ADDRESS: 614 PINE ST

Proposal: Construct rear addition and roof deck

Review Requested: Final Approval

OVERVIEW: This application proposes an addition on the two-story portion of the rear ell of 614 Pine Street, with a roof deck over the entire rear ell serviced by two pilot houses. Window openings on the rear of the main block and rear ell would be altered, and two skylights are proposed for the rear slope of the gable roof. The proposed work would not be visible from Pine Street but would be from Waverly and Addison Streets as well as a pedestrian greenway which runs from Pine Street to Addison Street.

Figure 7: West elevation of 614 Pine St, viewed from the greenway. Window openings in the purple rectangle would be relocated to align with the windows below. Window openings in the yellow rectangle would be lengthened.

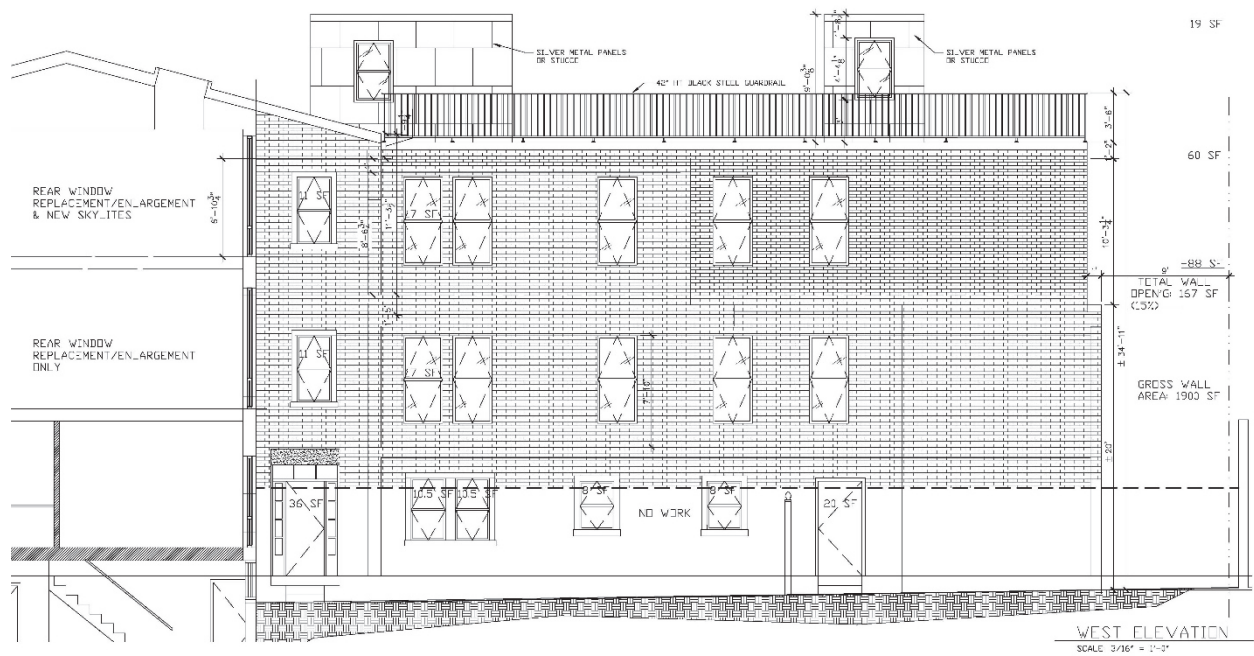
This application responds to previous feedback by proposing the entire addition be clad in brick. The fenestration plan now features one-over-one double-hung windows on the rear ell, with some windows enlarged and others relocated to match the window openings on the second and third floors. The design of windows proposed for the rear of the main block is not clearly defined in the application materials.

Figure 8: Current, revised, proposal.

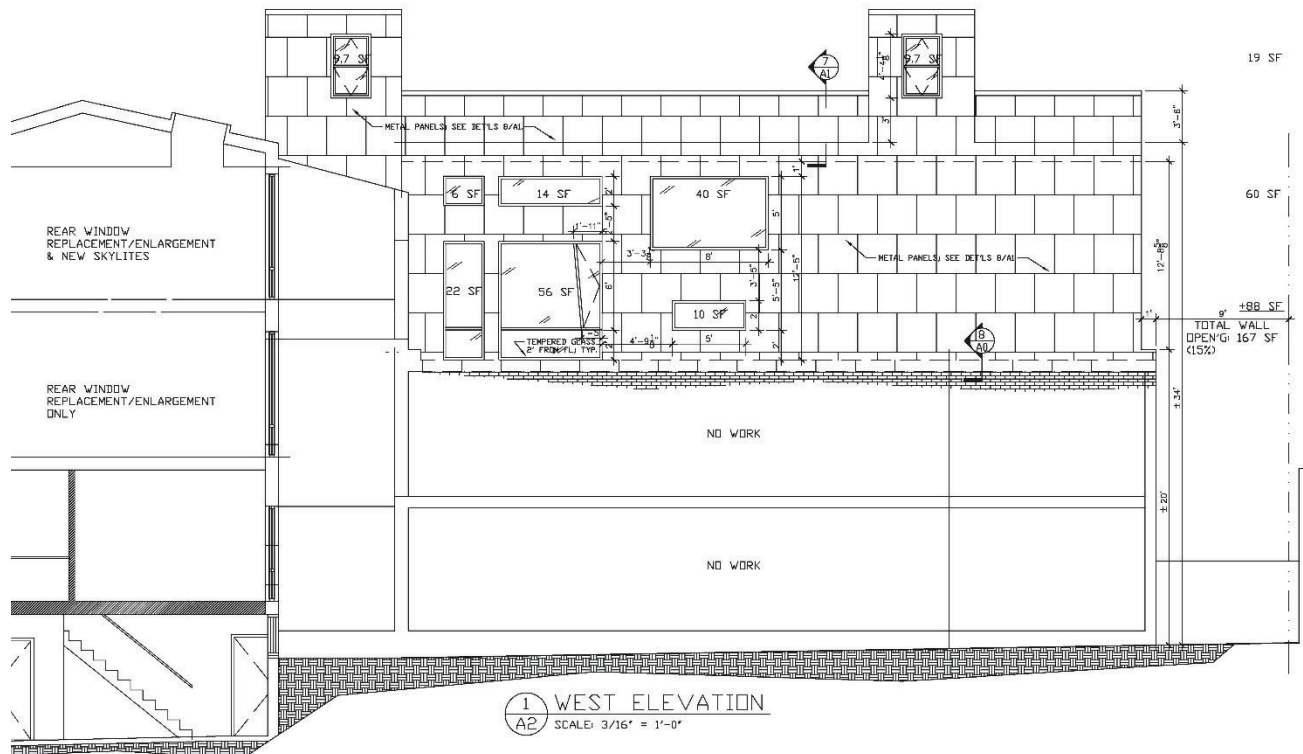
- The roof deck and pilot house would require the demolition of a small portion of the roof of the main block, though the amount of demolition is reduced compared to the original proposal.
- The proposal depicts the pilot houses clad in metal panels or stucco. Metal panels would not be compatible with the historic resource and would be highly visible from the pedestrian path and other public views. Appropriate cladding materials include stucco and fiber-cement siding.
- The roof deck with pilot houses would be inconspicuous and minimally visible from the public right-of-way and would not damage or obscure character-defining historic features, provided the cladding material is compatible.

STAFF RECOMMENDATION: Approval, provided the pilot-house cladding and main-block windows are compatible, with the staff to review details, pursuant to Standard 9 and the Roofs Guideline.

Figure 9: Original proposal, reviewed by the Architectural Committee in June 2025.

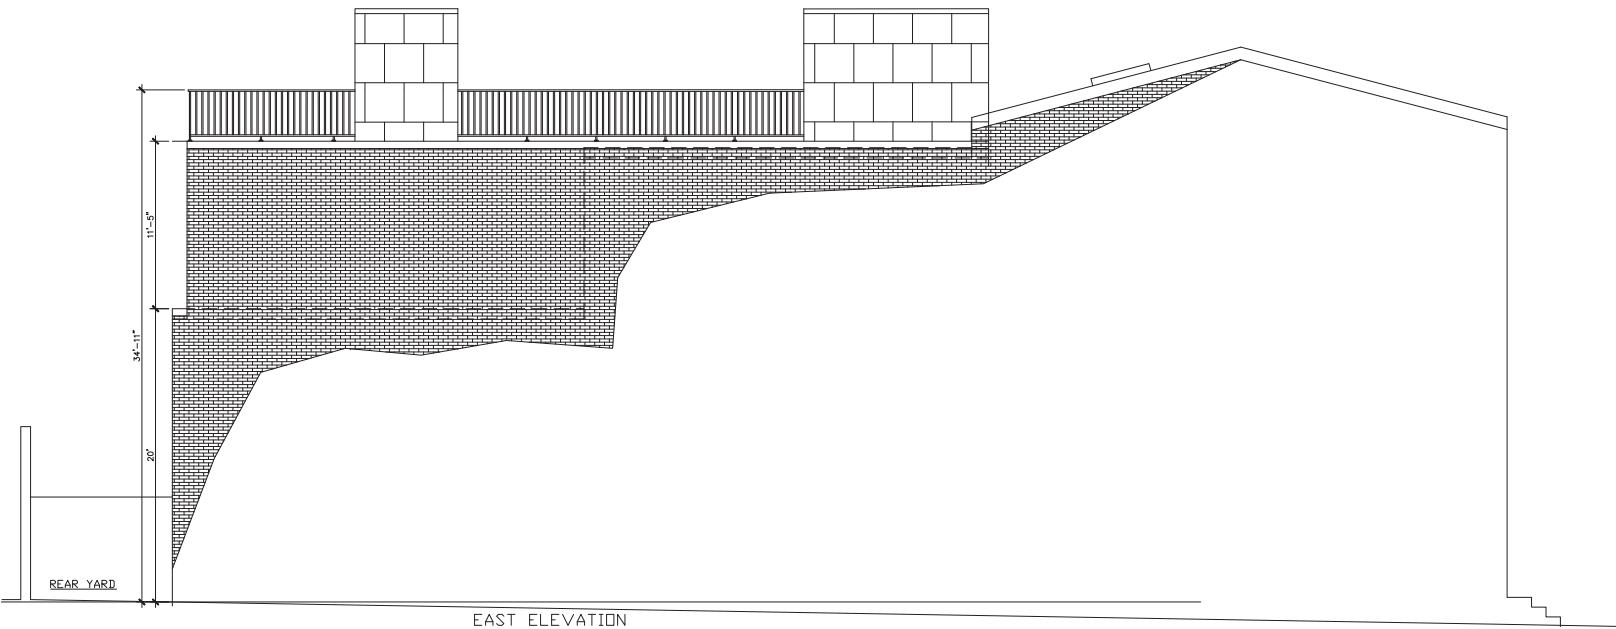
The Architectural Committee reviewed previous versions of this application and voiced concerns about the intersection of the front pilot house with the roof of the main block as well as the proposed use of metal panel cladding. The Committee asked that the fenestration be revised to something more compatible with the existing windows.
